TOWN OF BOXBOROUGH
NOTICE OF PUBLIC MEETING

BOARD/COMMITTEE: Board of Health
MEETING DATE: September 16, 2020
TIME: 7:30pm
PLACE: Virtual Meeting - this meeting is being conducted via Remote Participation, pursuant to the Current Executive Order. Remote participation instructions are provided below.

RE: 830 LIBERTY SQUARE RD - BOXBOROUGH, SEPTIC DESIGN

Project Name and Address
SEPTIC SYSTEM DESIGN FOR
OWNER/APPLICANT:
JOHN MURPHY
830 LIBERTY SQUARE RD
BOXBOROUGH, MASS.

VARIANCES REQUESTED

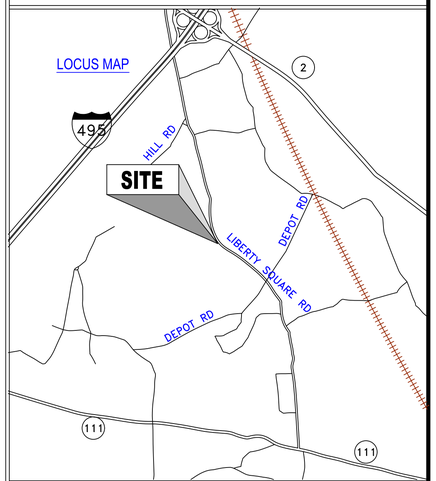
BOXOBOROUGH BOH REGULATION VARIANCES
REGULATION 6.4- BUILDING SEWER TIE-IN POINT (100' REQUIRED, 55' PROPOSED)
REGULATION 6.5-SEPTIC TANK TO PROPERTY LINE (20' REQUIRED11.9' *ROPOSED)
-EXISTING AND PROPOSED BUILDING SEWER WITHIN 100' OF WELL.
REGULATION 7.2 - NGVD 1929 DATUM REQUIRED, ASSUMED DATUM PROPOSED.
-UTILIZING AN INNOVATIVE/ALTERNATIVE (I/A) SYSTEM, DESIGN PROPOSES A 2' SEPARATION DISTANCE FROM SAS BOTTOM TO ESHGW [4' REQUIRED, 2' PROPOSED] .
